### **Cumulative Development in Thurston**

This letter updates Suffolk County Council's position as the Highways Authority on the five planning applications that were presented to the Mid Suffolk District Council Planning Committee on the 12<sup>th</sup> July 2017.

Fig 1: AECOM Drawing ref: 60445024-SKCC\_004-A

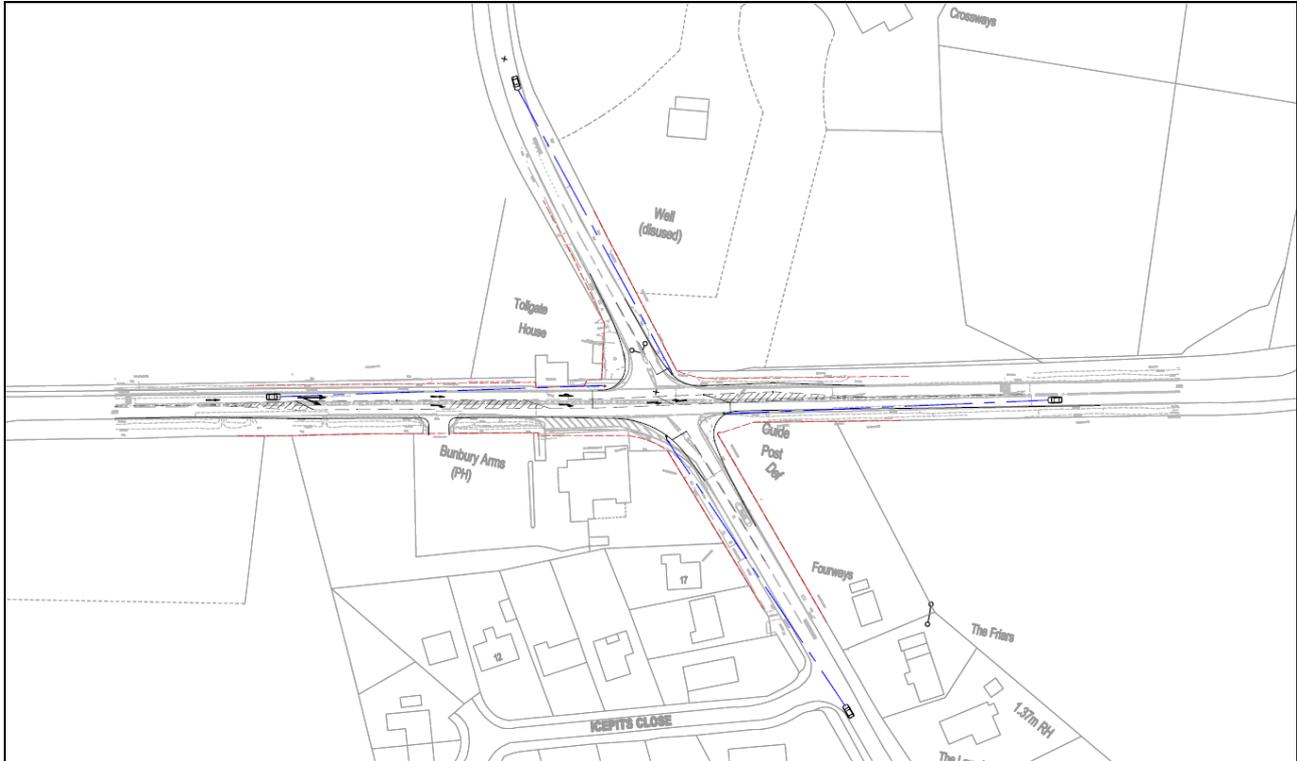
The main issue at this junction indicated by early studies was the lack of capacity. Queueing occurs on Thurston Road approaching the A143 in the morning and on the A143 in the evening due to vehicles from Bury St Edmunds turning into Thurston Road. The proposed mitigation is to introduce right hand turn lanes with traffic signals to control the junction.

Drawing ref 60445024-SKCC\_004-A (Fig 1 below) shows the indicative layout. A reduction in vehicle speeds is required due to the narrow lanes which in turn are restricted by the available highway land. During the detailed design, every effort will be made to increase the width of the lanes although the requirement for the reduced speed limit will remain

Without any highway improvements and with the proposed development the junction will be operating at considerable over capacity. Junction modelling indicates that the proposed traffic signal option will increase capacity although with the proposed development the junction will be close to the theoretical capacity in 2021.

As part of the study a Road Safety Audit was undertaken. Although this has raised a number of design issues it is considered that these can be addressed during the design process.

Fig 4: Proposed modified junction layout AECOM drawing 60445024-SKE-C-008-A

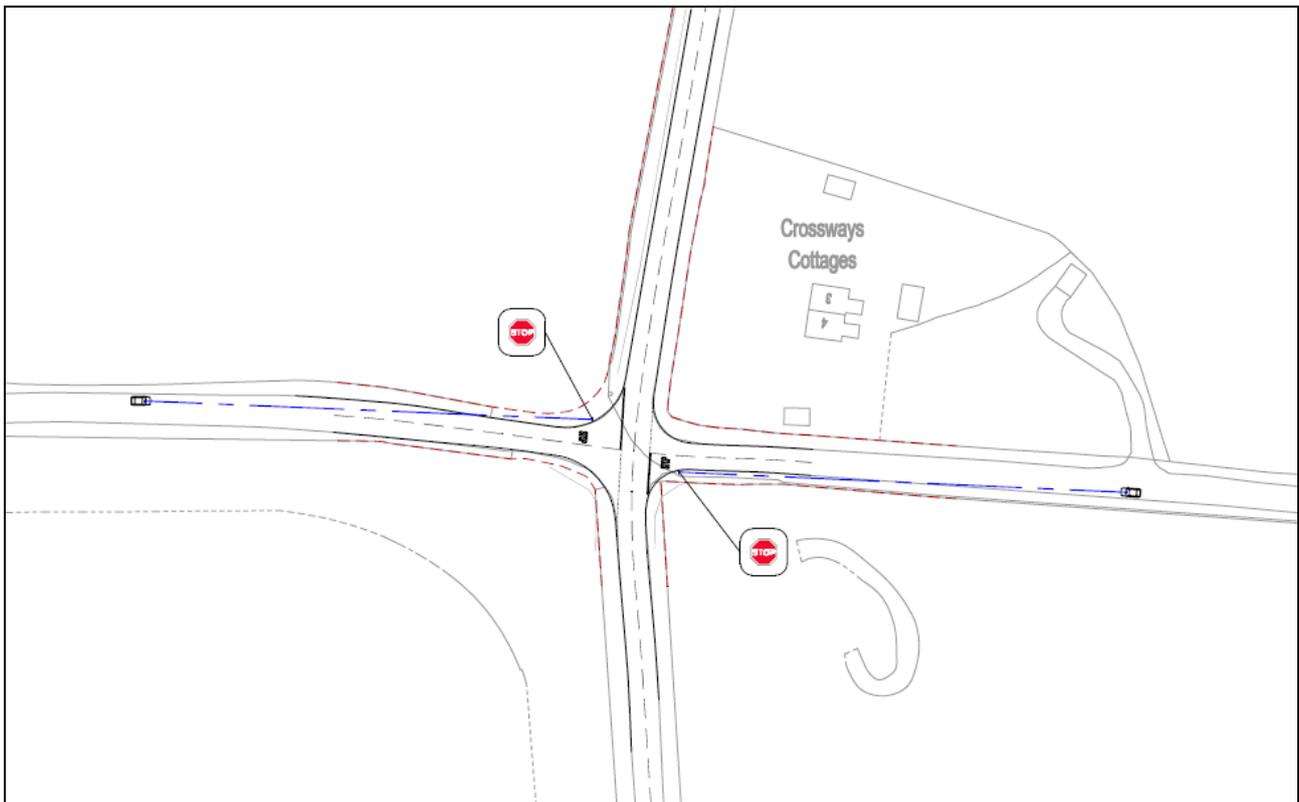
As this junction was shown by the initial study to be operating over-capacity the Applicants were challenged to suggest possible mitigation measures. Following these discussions, a proposed scheme to change the priorities at the junction was selected for further study. This change provides two benefits

- An increase in capacity by prioritising those arms of the junction with the heaviest traffic
- By reducing speeds and providing stop lines rather than give way road safety can be improved.

To confirm that these assumptions are correct indicative drawings have been prepared to make sure large vehicles can use the revised junction. In addition, modelling has been undertaken to confirm that the capacity can be improved and a road safety audit to identify any safety concerns. The modelling shown in Fig 5 shows that the capacity can be increased

The road safety audit identified vegetation and vehicle speeds as two potential issues. The designers' response considers that both can be addressed during the detailed design process.
